Planning & Development Division
Planning & Economic Development Department

File Number	PL 21-188	Contact	Kyle Deming	
Type	Final Plat	Planning Commission Date		January 11, 2022
Deadline for Action	Application Date	December 9, 2021	60 Days	February 7, 2022
	Date Extension Letter Mailed	December 22, 2021	120 Days	April 8, 2022
Location of Subject		Northwest of intersection of Skyline Pkwy and U.S. Hwy 2 (Bayview Heights)		
Applicant	Cynthia Crawford	Contact		
Agent	Northland Consulting Engineers	Contact	David Bolf	
Legal Description		See attached		
Site Visit Date		September 9, 2021	Sign Notice Date	NA
Neighbor Letter Date		NA	Number of Letters Sent	NA

Final Plat of Skyline View Estates to subdivide 67.71 acres into 13 lots along a public street.

Staff recommends approval, with conditions.

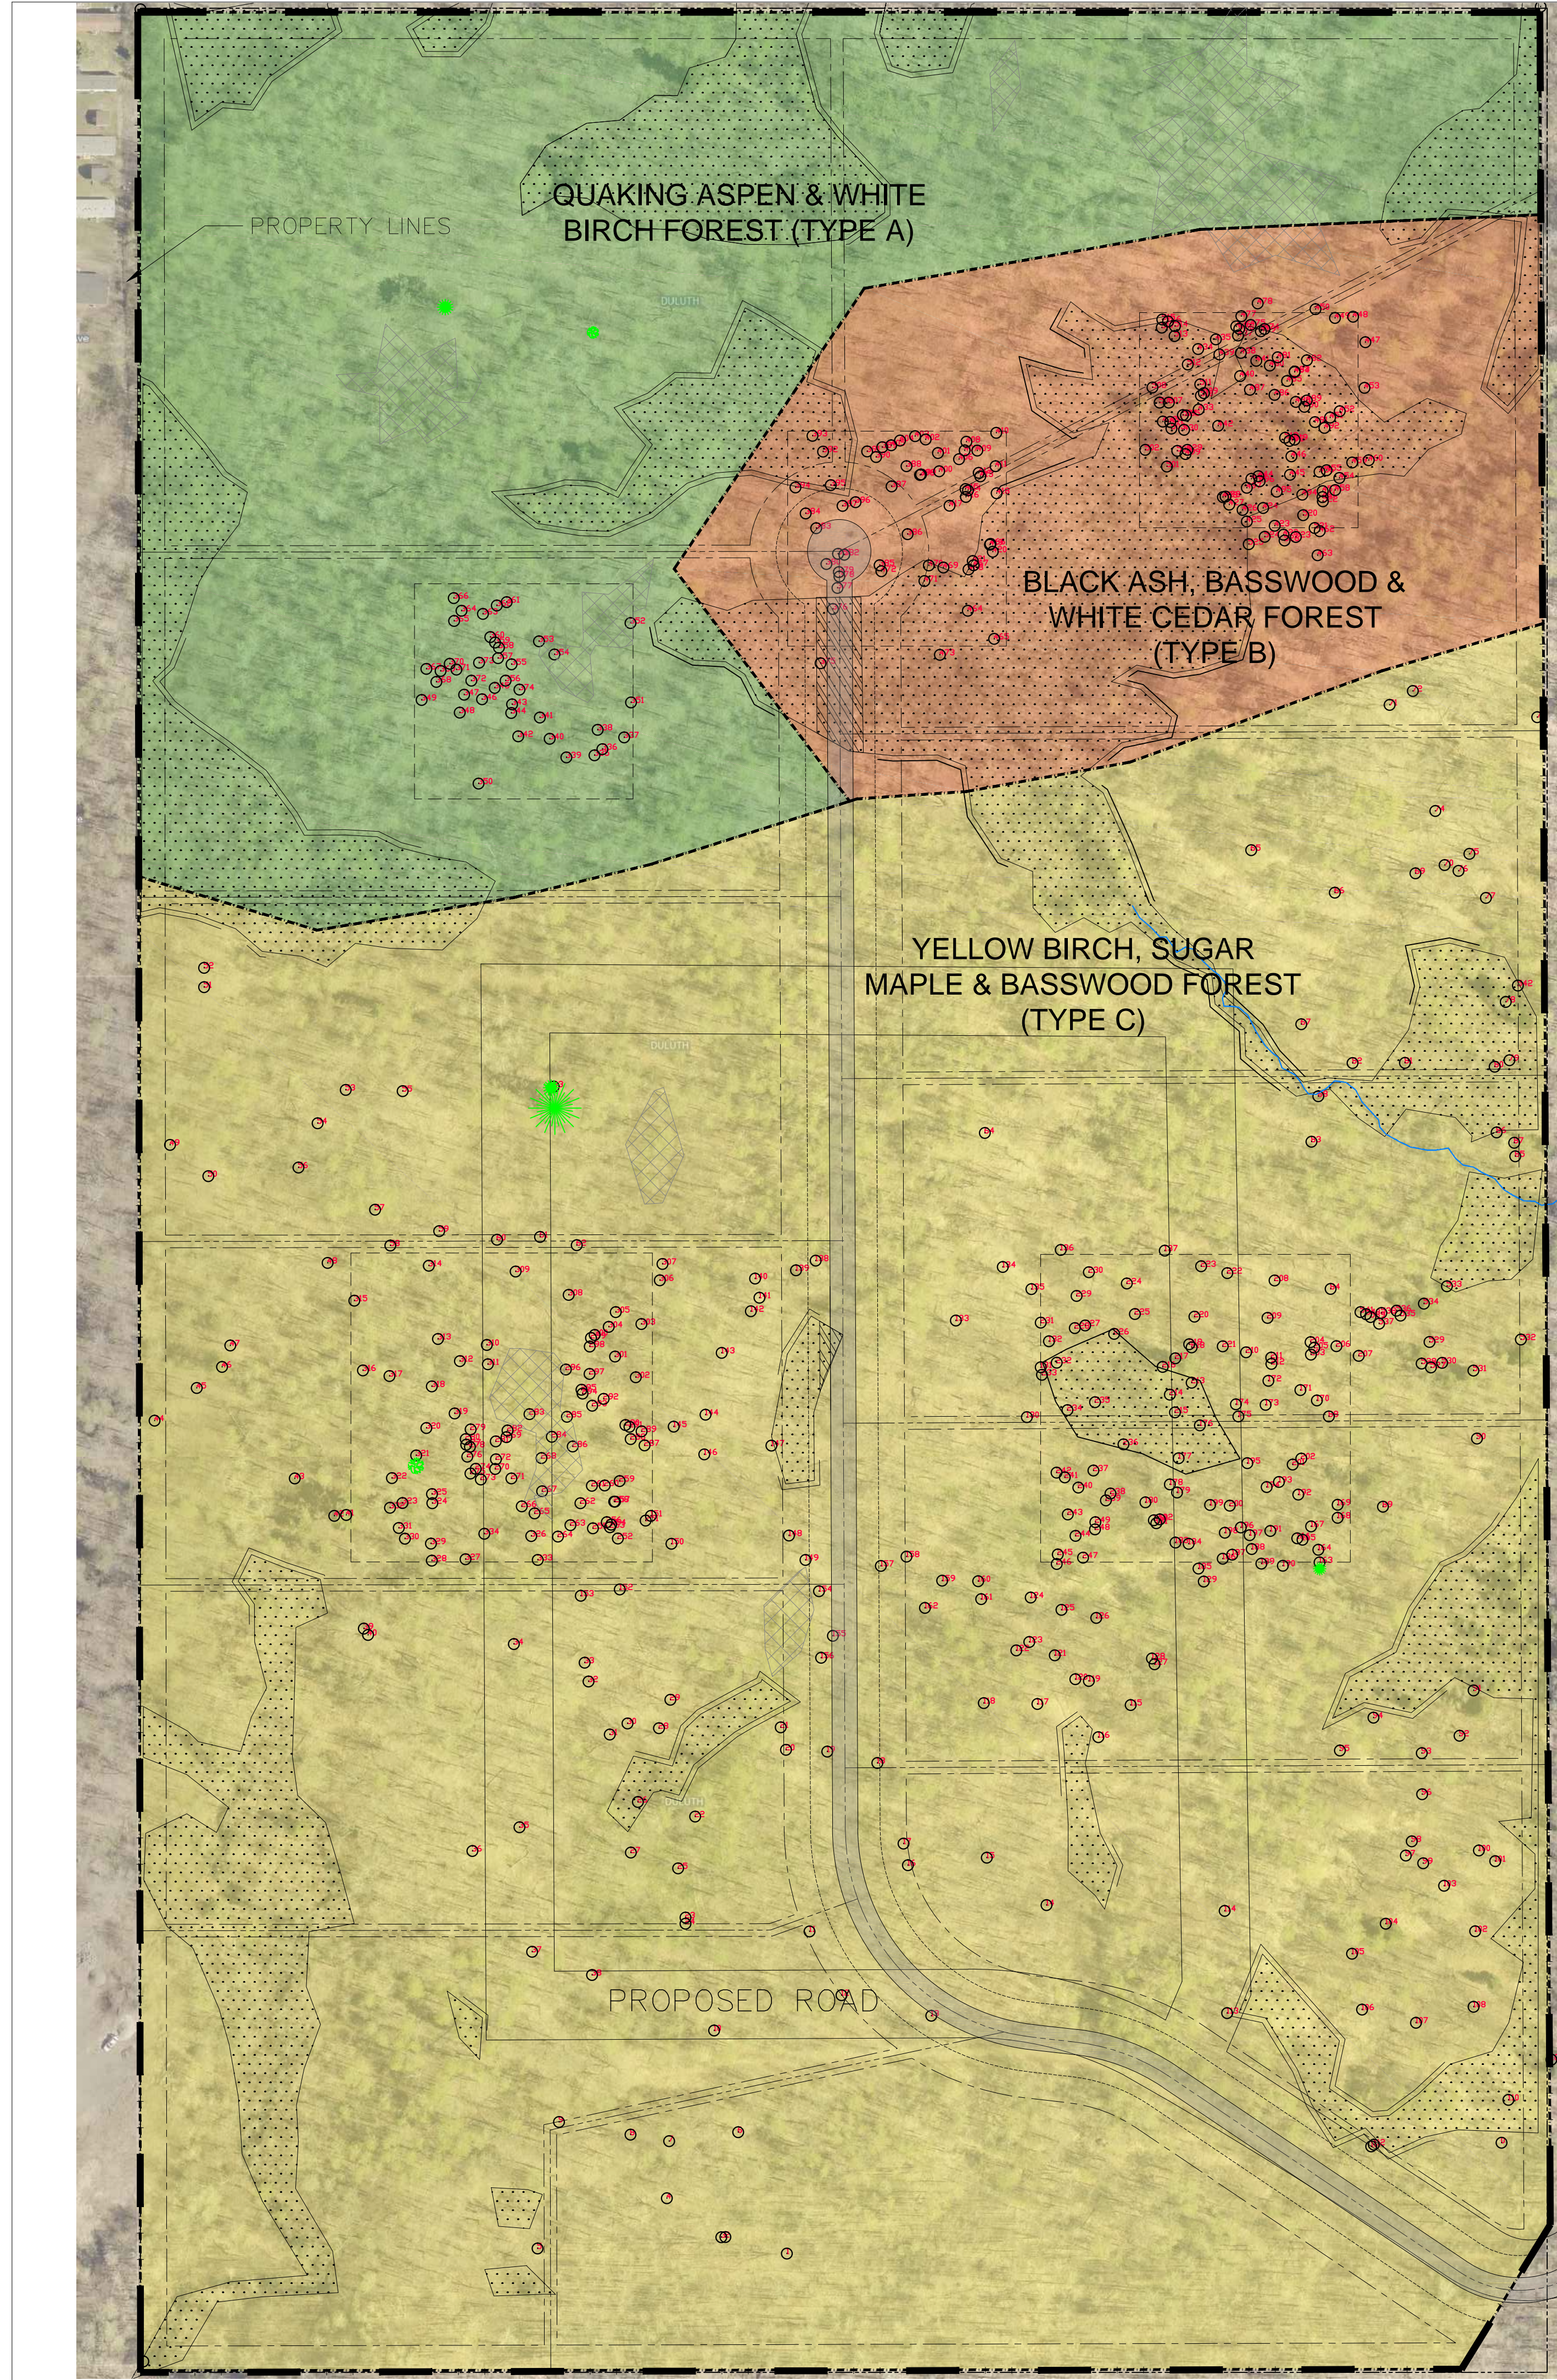
- e. A Wetland Replacement Plan application has been submitted by the developer according to the State's Wetland Conservation Act (WCA) to allow impacts to 0.26 acres of wetlands due to construction of the public street and 0.05 acres of wetland impact due to private driveways on 2 lots (see attached). The WCA rules require impacts to be limited to those quantified in the application and enforcement tools are in place to require restoration of unpermitted impacts. Additionally, the Development Agreement requires construction fencing around portions of wetlands proposed for impact.
